Access Compliance Report Public Rights-of-Way (Curb Ramps)

Main Street: BENETA_WAY Cross Street: LIVINGSTON_AVE Location: NE

ADA ID: RPAT211004095922 Ramp Type: Type 1 - Perpendicular Diagonal Initial Pass/Fail: Pass Overall Compliance: No Severity Score: 0

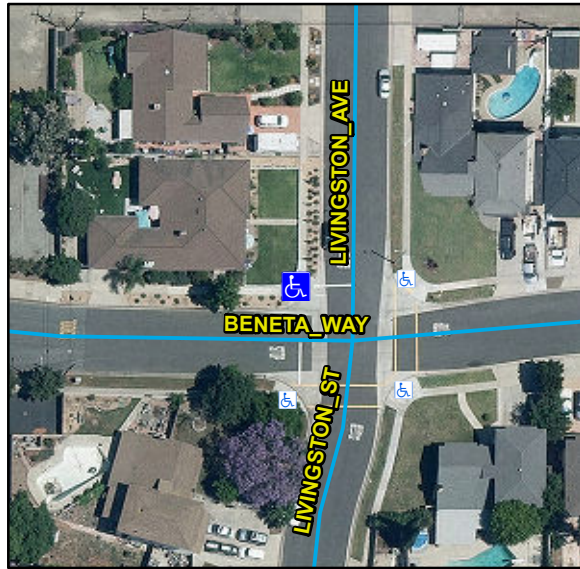
R304.2.2, R304.2.2-Perp, R304.3.2-Para, STD 1115

Remove & Replace Curb Ramp With Two New Directional Ramps or Equivalent.
